**Group of Experts on European Agreement Concerning Work of
Crews of Vehicles Engaged in International Road Transport (AETR)**

Annex 1C

Submitted by the European Commission

*LIST OF PROPOSED CHANGES TO ANNEX 1C FOR AETR
V0.4 20190403*

Current image in CSM_010

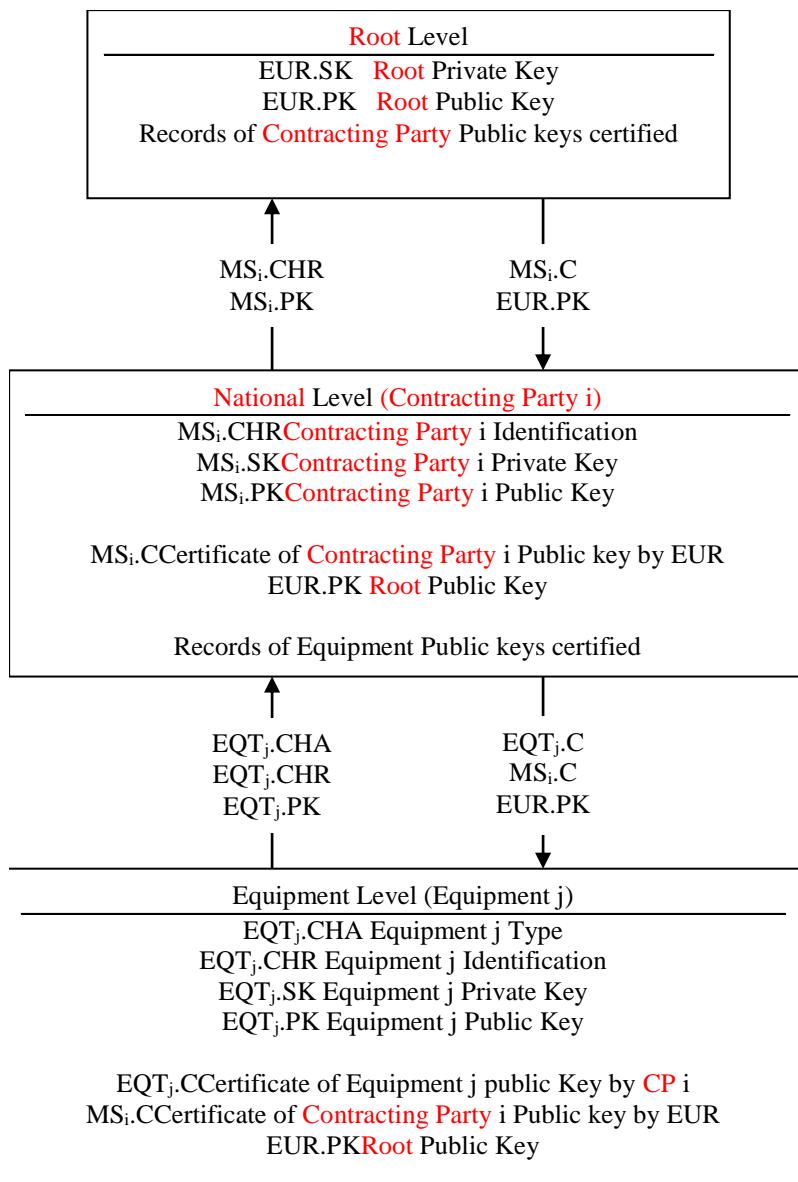
New proposed image
